**DEFENSE NUCLEAR FACILITIES
SAFETY BOARD**

Staff Report

Savannah River Site 296-H Tritium Stack Structural Review

Figure 2. Example Cross-sections for Vertical and Horizontal (“confining”) Reinforcement
(a) Single Layer of Reinforcement (b) Two Layers of Reinforcement (“two face”)
[Note: These are not cross-sections of the 296-H stack]

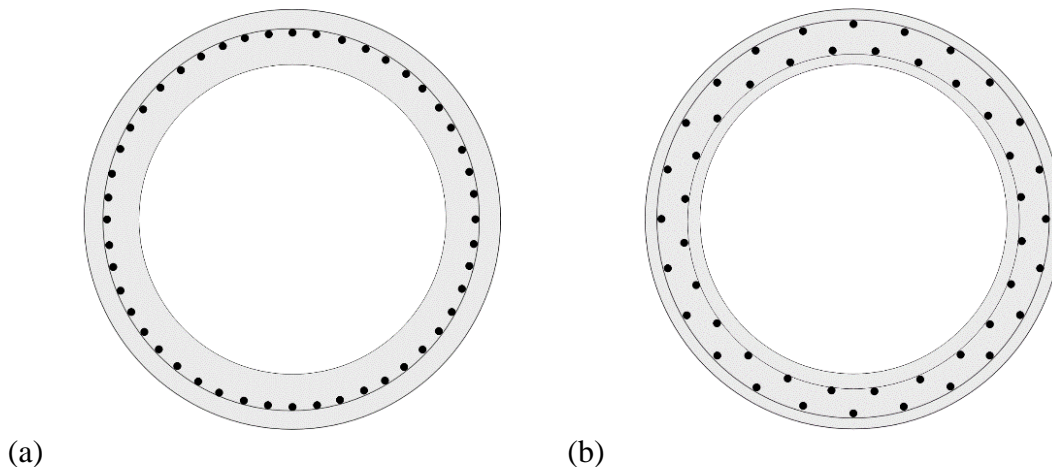
Single Reinforcement Design—Due to the vintage of the 296-H stack, it was designed with dated practices. In particular, the stack only contains one layer of vertical reinforcing steel along its length and only one layer of circumferential (confining) reinforcing steel in the horizontal direction. Figure 2 compares a single reinforcement configuration with a two-layer (“two-face”) reinforcement configuration. American Concrete Institute Standard 307-08, *Code Requirements for Reinforced Concrete Chimneys* [10], states the following in its commentary Section R4.1 (emphasis added):

*For the 1995 edition, the Committee re-evaluated the previous exemptions regarding two-face reinforcement and minimum wall thickness for chimneys 300 ft or less in height and less than 20 ft in diameter. Recent information has indicated that two-face circumferential reinforcement is necessary to **minimize vertical cracking** due to radial wind pressures and reverse thermal gradients due to the effects of solar heating.... [T]he current committee believes that two-face reinforcement should be required in all chimney columns, regardless of size, considering the **aggressive environment surrounding chimneys**.*

Since SRNS does not inspect the interior of the 296-H stack, the presence of vertical cracks within the stack has not been determined. It is SRNS’s position that there are likely no

interior vertical cracks since they would propagate through the thickness of the stack and be seen on the exterior of the stack. However, the Board's staff notes that interior vertical cracks may not manifest themselves on the exterior of the stack due to the presence of confining steel surrounding the vertical reinforcement.
